To: T10 Technical Committee
From: Rob Elliott, HP (elliott@hp.com)
Date: 2 May 2006
Subject: 05-381r3 SAS-2 Multiplexing

Suggested changes to SAS-2

Figure 3 — Phy class diagram

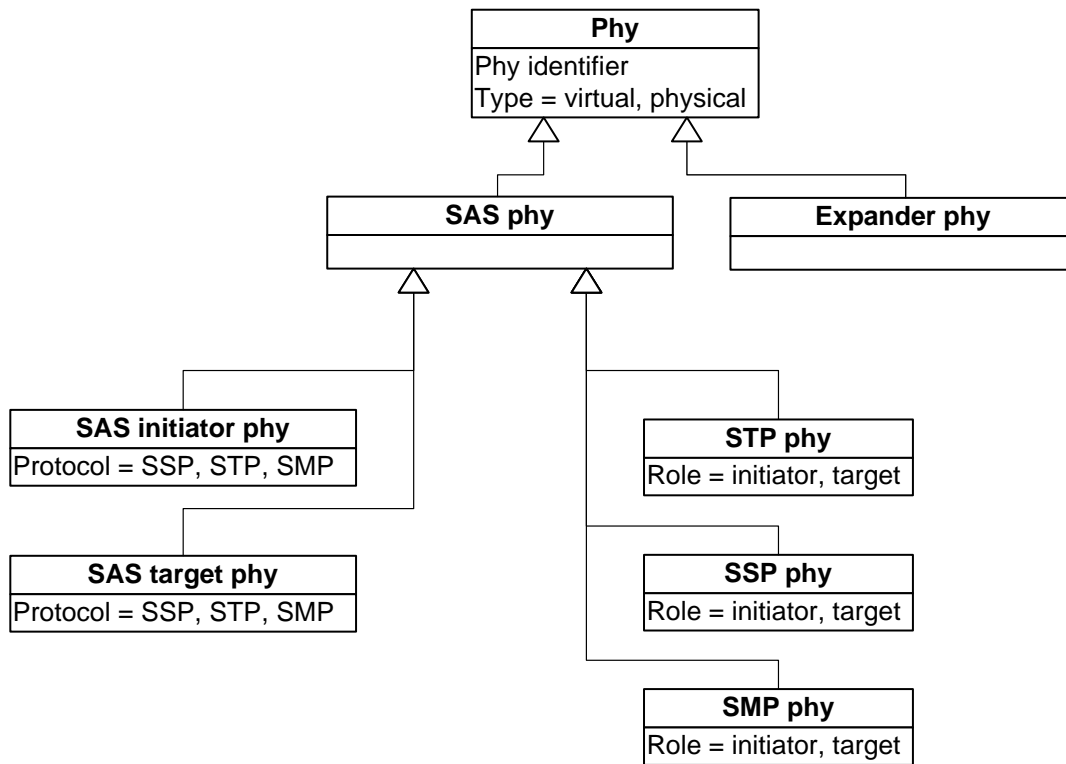
Editor's Note 1: Logical phys (SAS logical phys and expander logical phys) need to be included in the UML model.

Figure 13 — Reset terminology [\[updated to add multiplexing sequence\]](#)

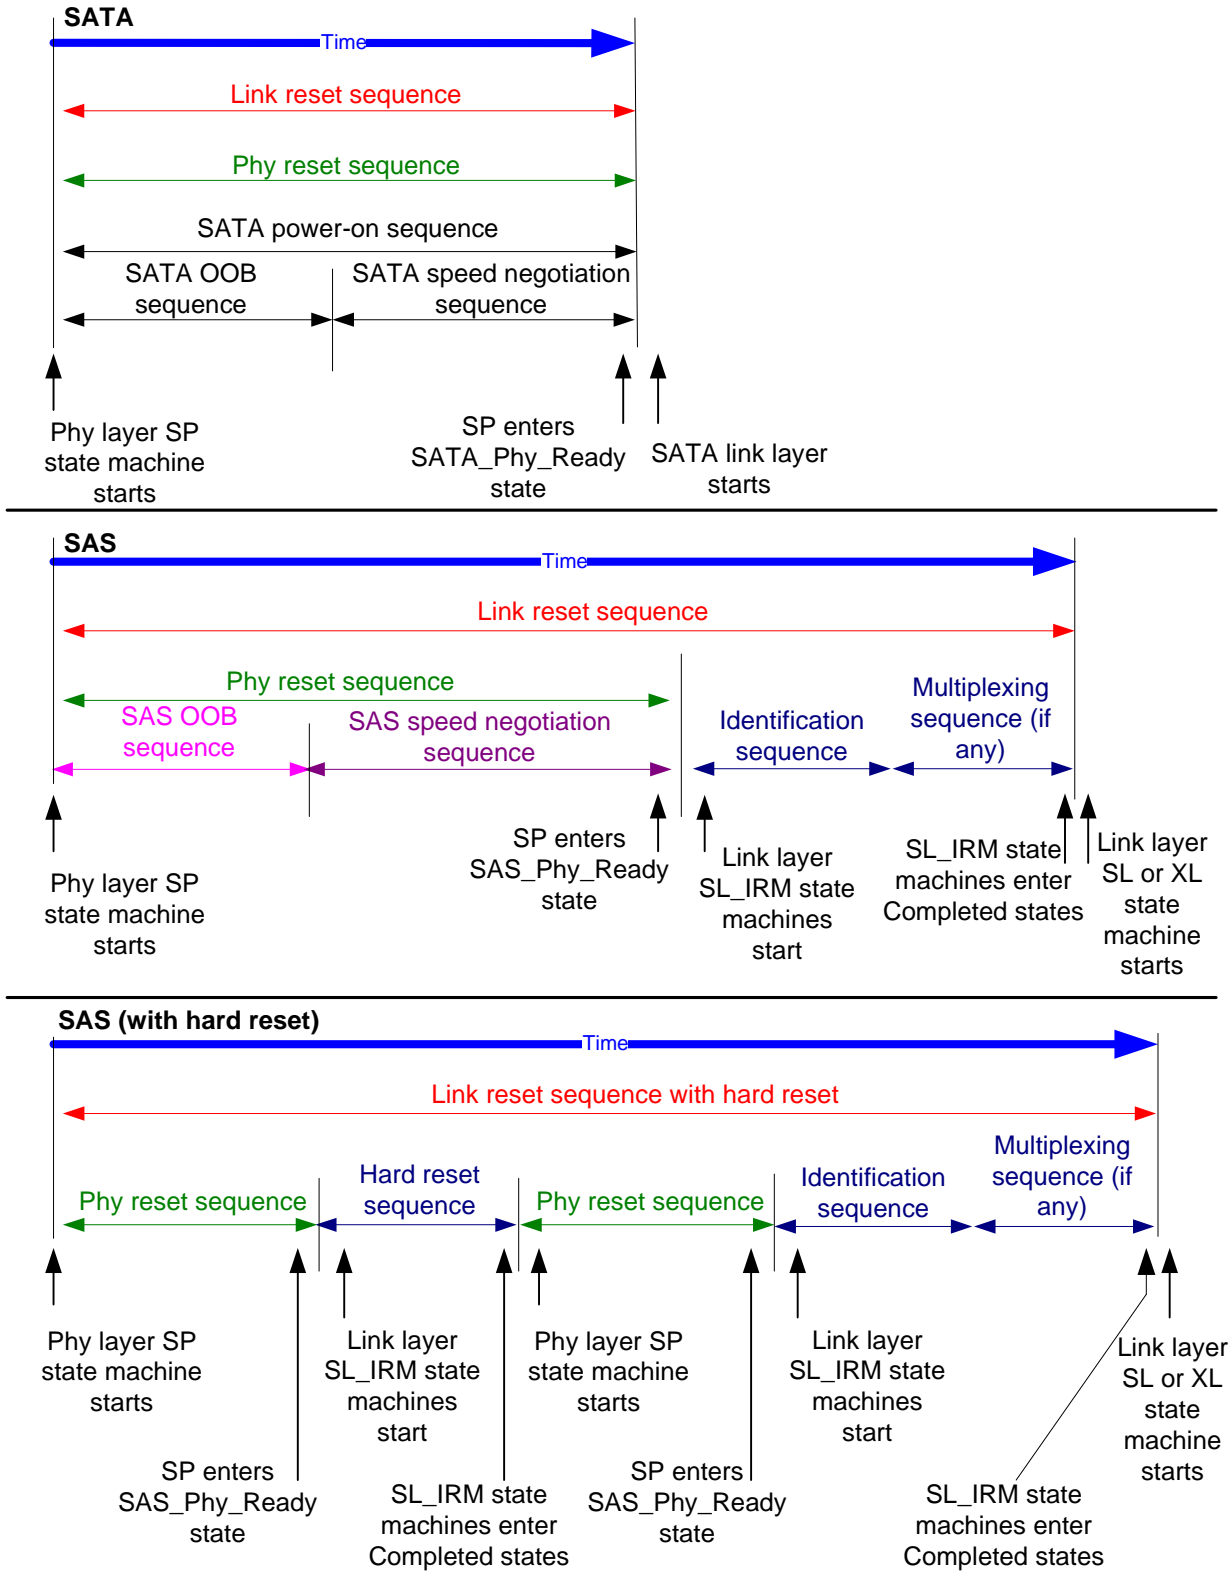
- link reset sequence;
- phy reset sequence (see 6.7);
- SATA OOB sequence (see 6.7.2.1);
- SATA speed negotiation sequence (see 6.7.2.2);
- SAS OOB sequence (see 6.7.4.1);
- SAS speed negotiation sequence (see 6.7.4.2);
- hard reset sequence (see 7.9);
- identification sequence (see 7.9); [and](#)
- [multiplexing sequence \(see 7.9.xx\).](#)

Figure 21 — Identification sequence

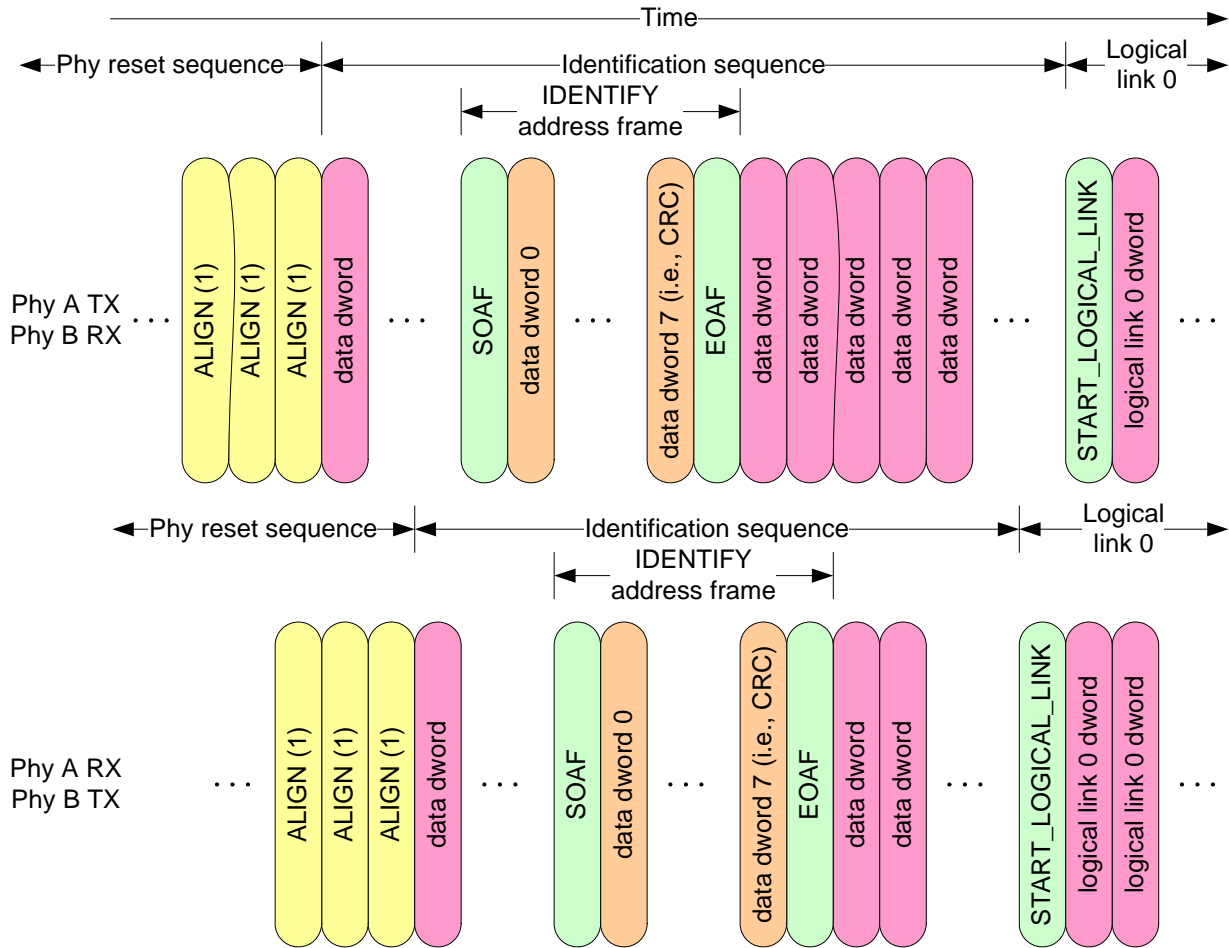
Editor's Note 9: May want to show this leading into the multiplexing sequence as well

Figure 26 — SL_IRM (link layer identification, and hard reset, and multiplexing) state machines

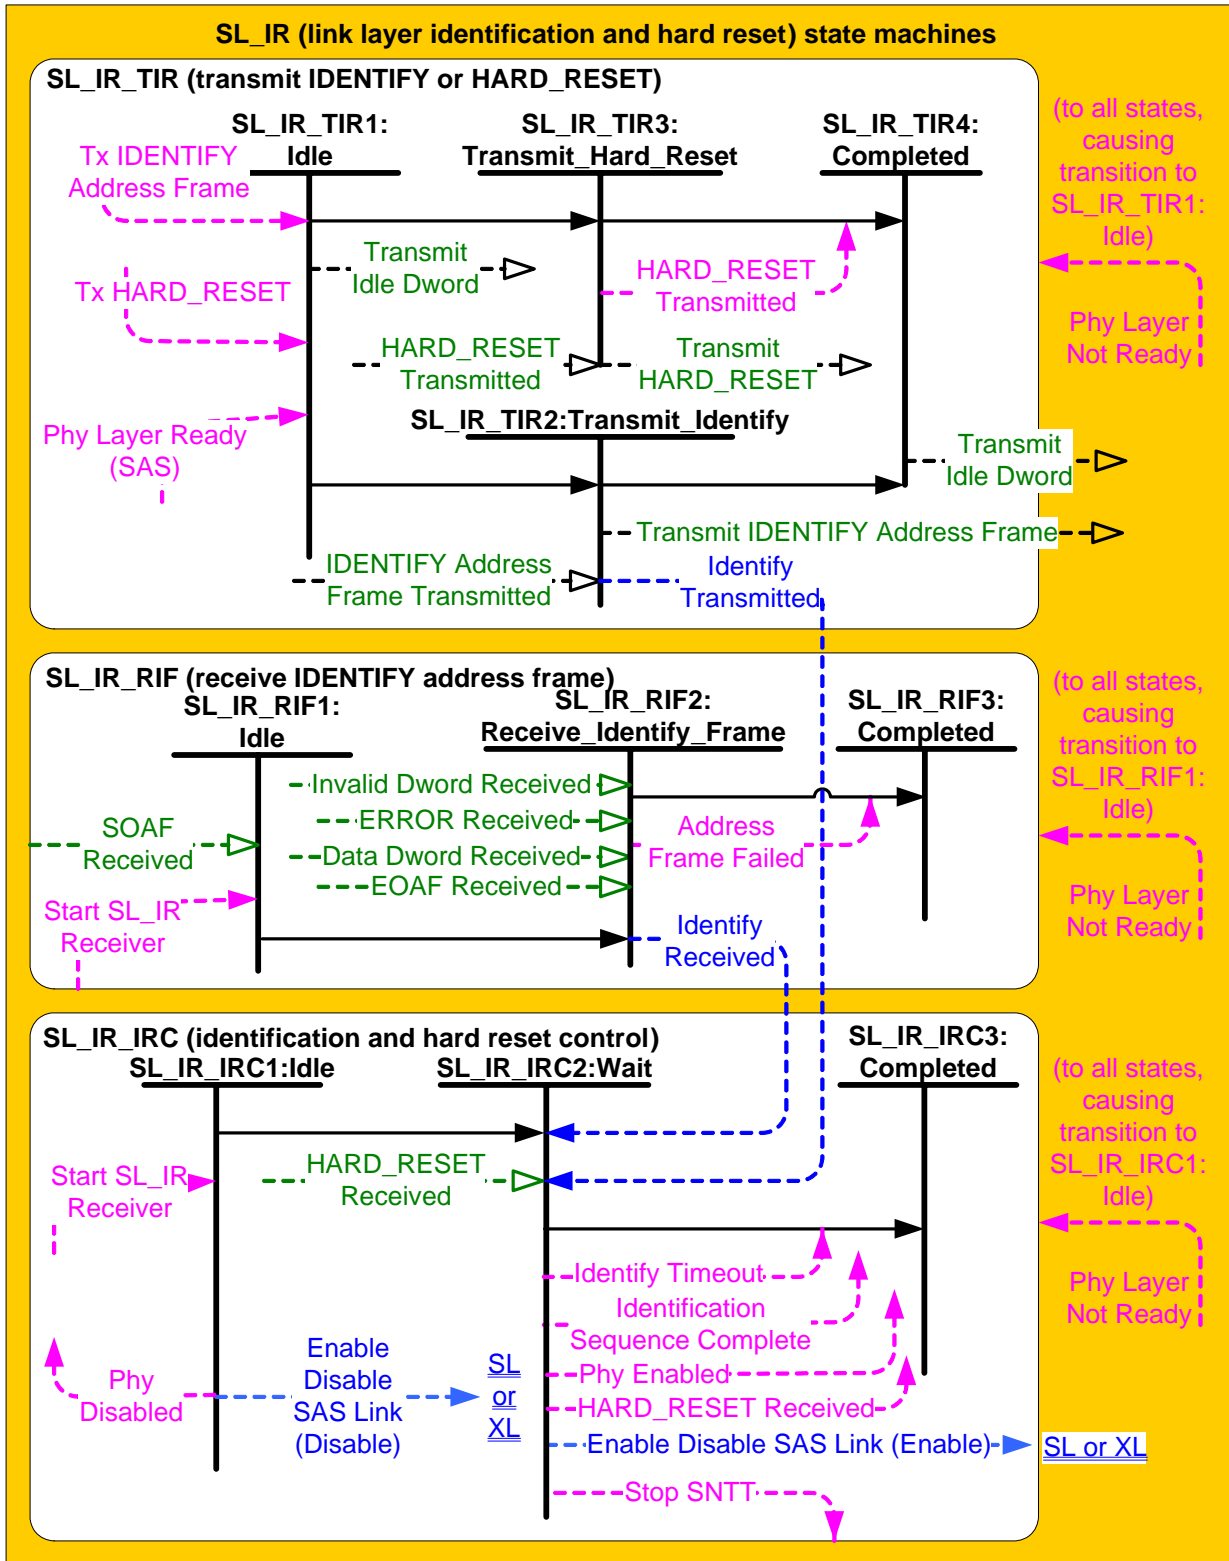
[Editor's Note 12: Add state\(s\) to handle the multiplexing sequence.](#)
